**MACLEAN HOLLOWAY
DOHERTY & SHEEHAN, P.C.**
ATTORNEYS AT LAW

February 21, 2018

Re: Modification of Approved Special Permit and Definitive Subdivision Plan at Donahue Court

PLAN OF LAND
IN
NEWBURYPORT, MASSACHUSETTS
SHOWING
PROPOSED SINGLE-FAMILY DWELLING
LOT 4A DONAHUE COURT

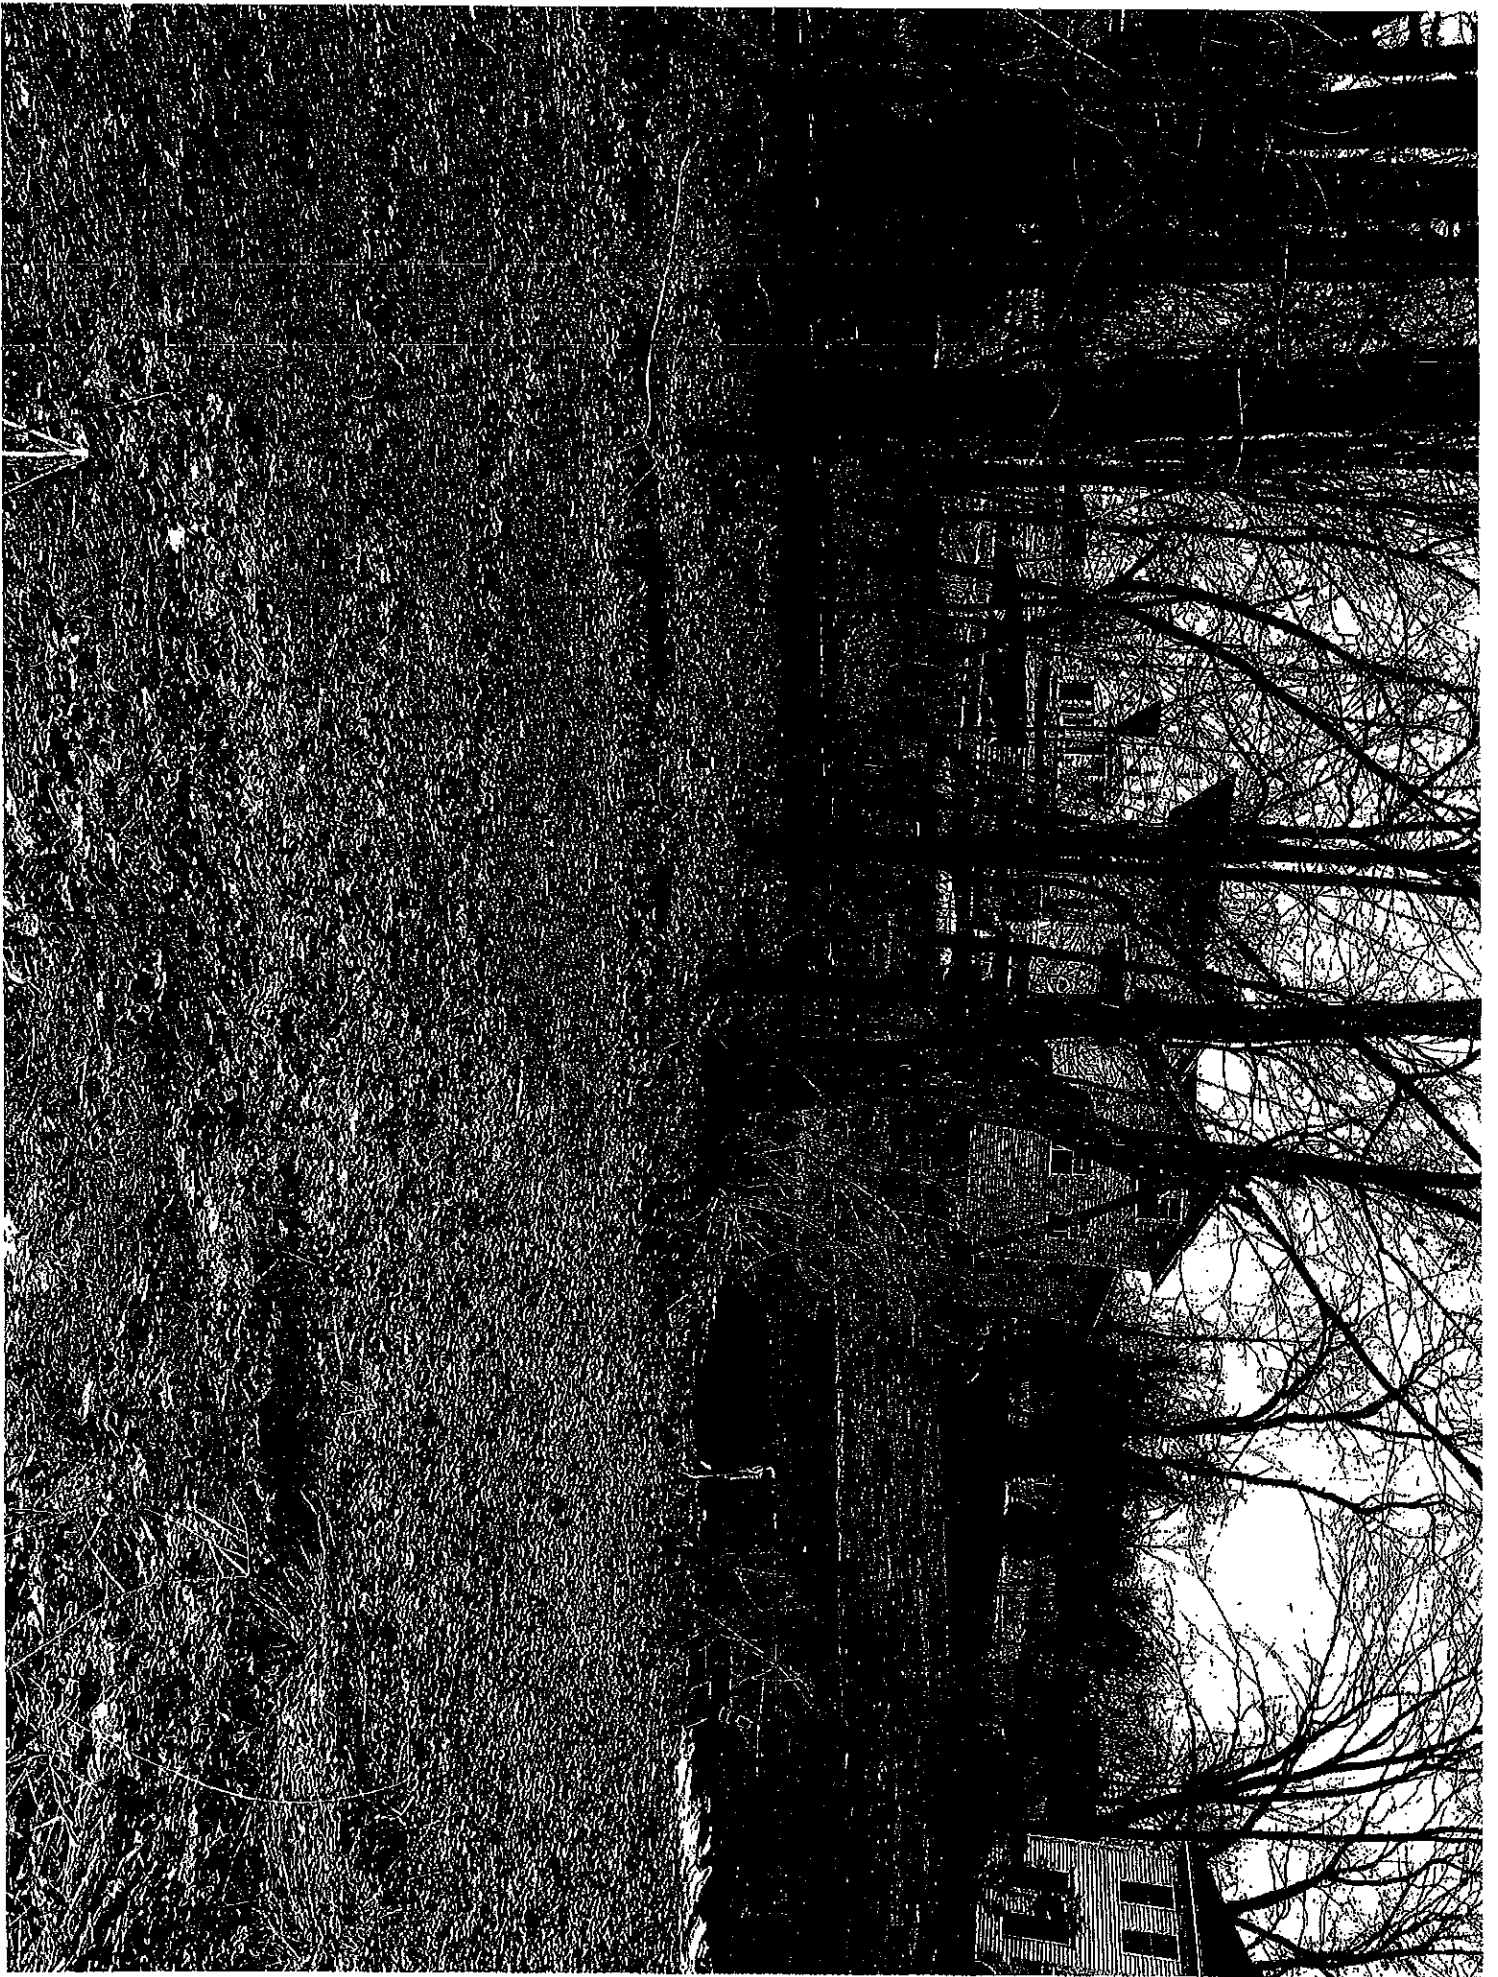
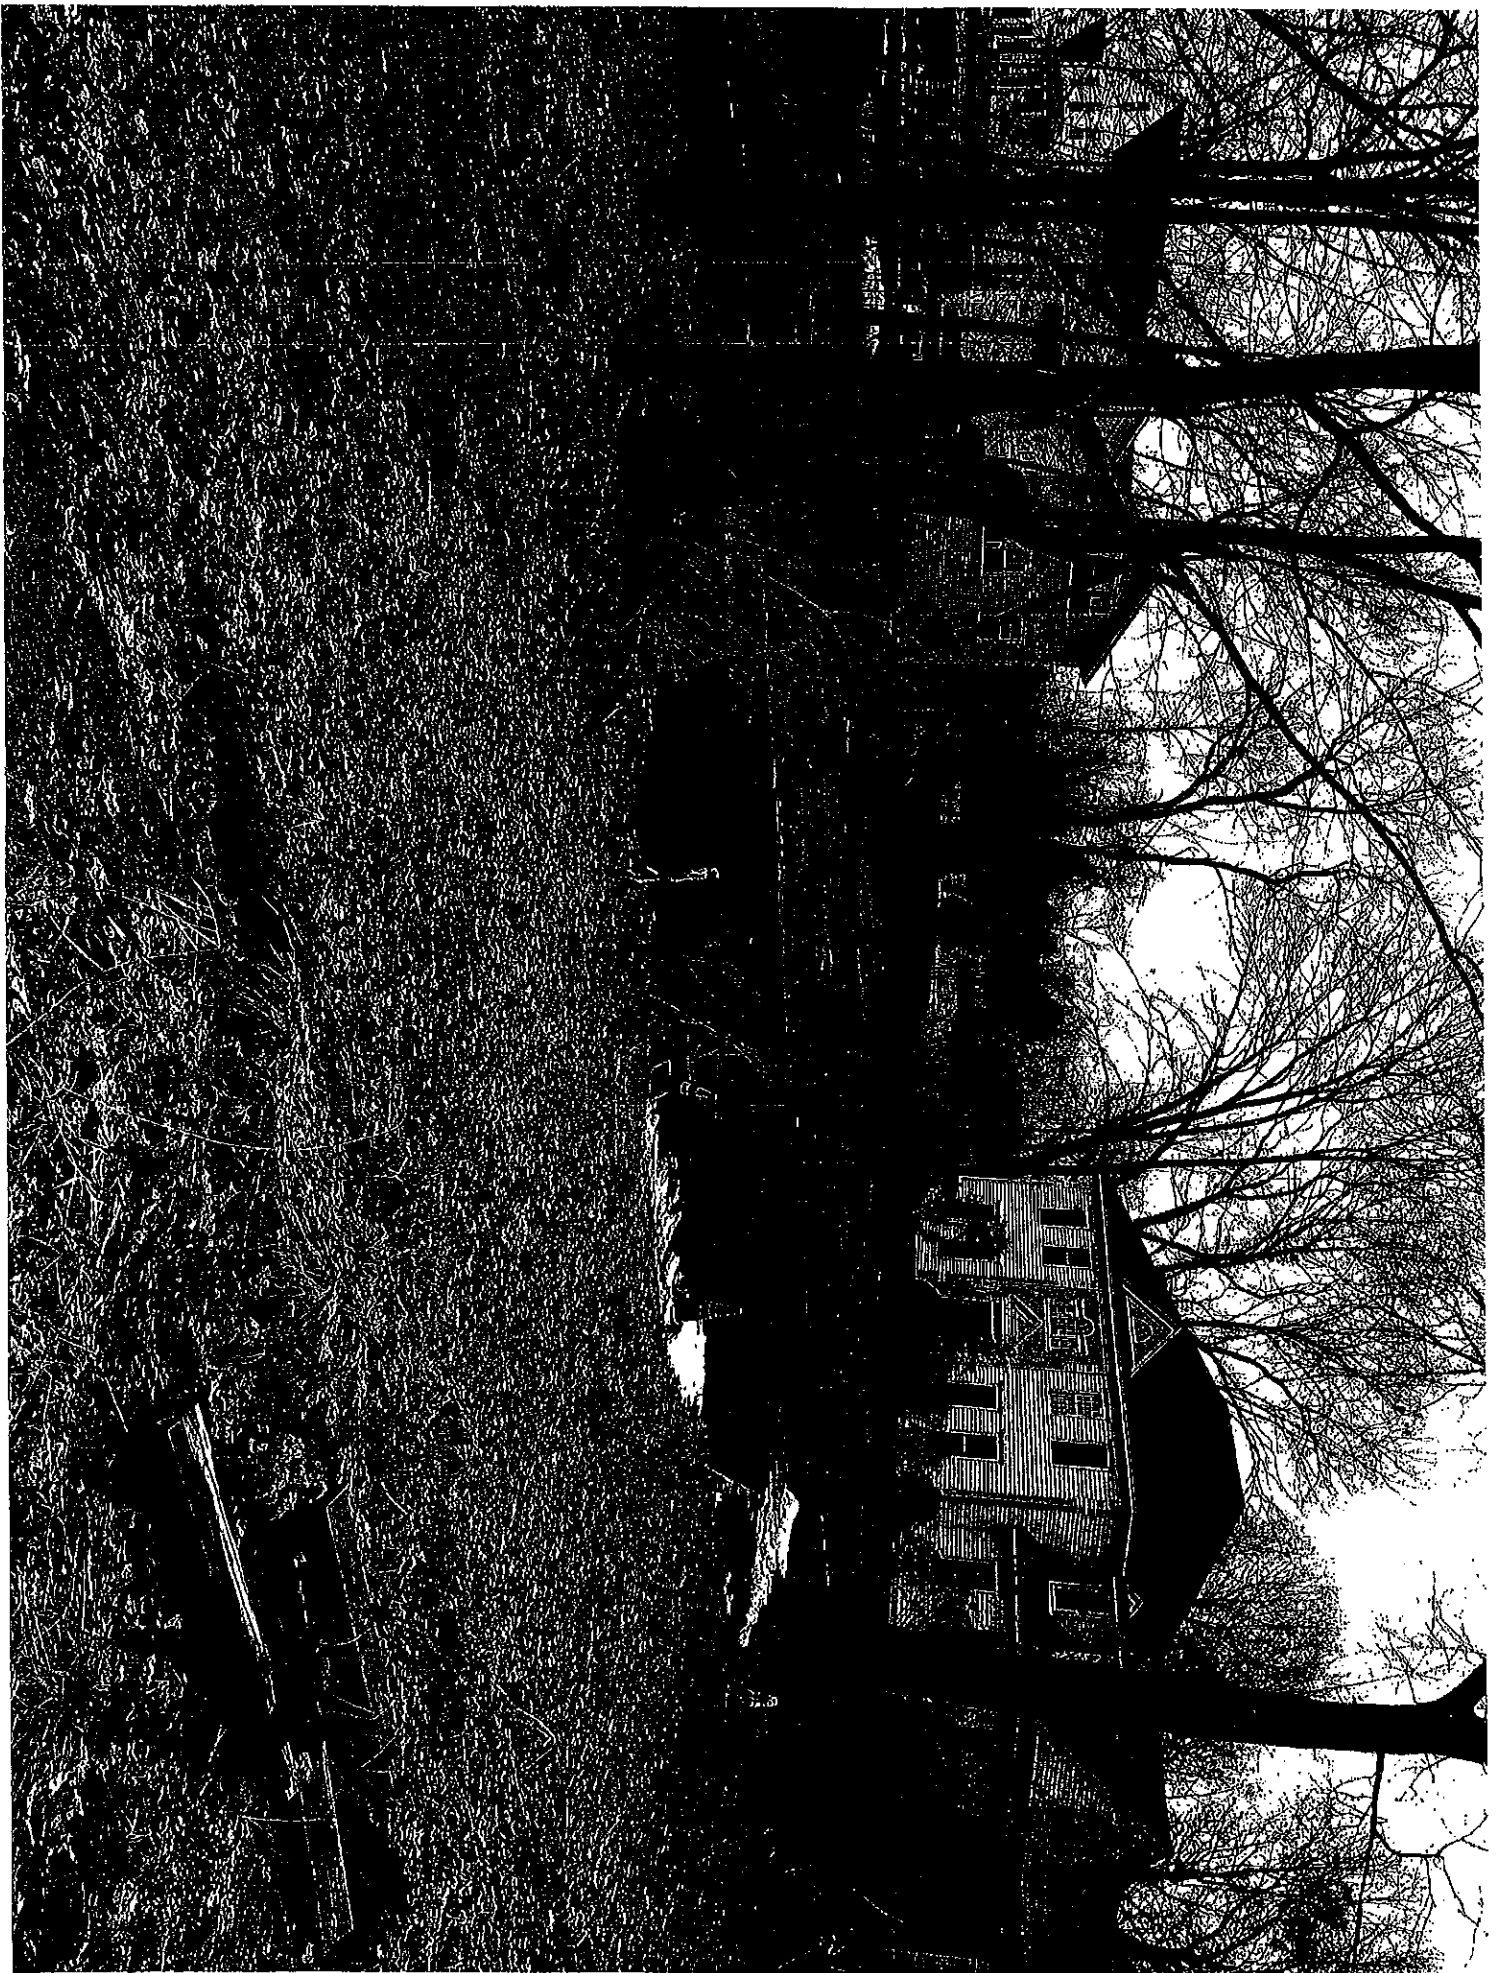
The Site Plan modifies and improves on those plans included in the Definitive Subdivision Plan as follows: enlargement of the house footprint from approximately 2,230 square feet to 3,818 square feet; enlargement of the driveway area from 1,720 square feet to 3,440 square feet; inclusion of stone walls; enlargement of basketball court; inclusion of stone trench to infiltrate stormwater runoff from enlarged basketball court; enlargement in area of detention basin from 233 square feet to 440 square feet due to enlargement of house footprint and driveway area; and more detailed site grading. Prior to the March 21, 2018 Board hearing, the Applicant will submit to the Board a supplemental site plan for the Property showing, *inter alia*, his proposed tree implants and other screening mechanisms for the shared boundary line with the Eramos discussed *supra*.

For the reasons discussed above, the Applicant respectfully requests that the Board modify the previously approved special permit and definitive subdivision plan consistent with the Stormwater Calculations and Site Plan enclosed herewith.
